Application No. 10/713,437

Application No. 10/713,437 Amendment Dated November 11, 2005 Reply to Office Action of September 1, 2005 Annotated Sheet Showing Changes

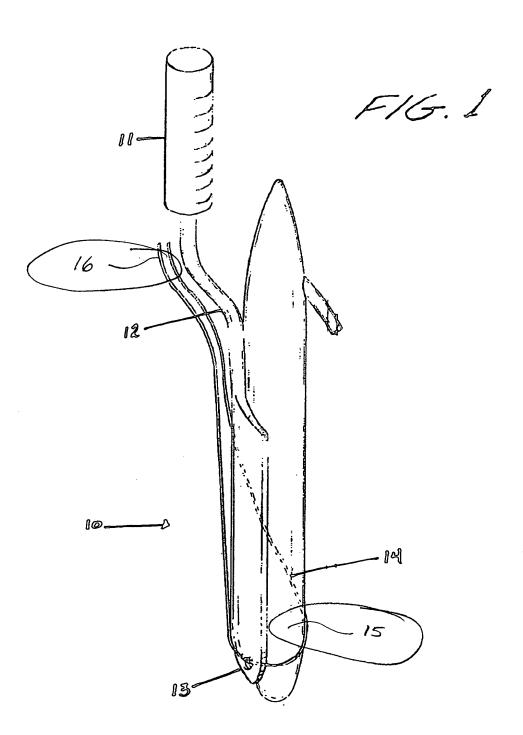
Fig. 1 has been amended to include additional item numbers that correspond with the

description amended in the specification. Specifically, item numbers 15 and 16 have been added

to Fig. 1, wherein item number 15 is the outwardly angled shaft section and item number 16 is

the linear handle section.

Applicant has amended Fig. 1 to include additional item numbers that correspond with the description amended in the specification. Specifically, item numbers 15 and 16 have been added, wherein item number 15 is the outwardly angled shaft section and item number 16 is the linear handle section.
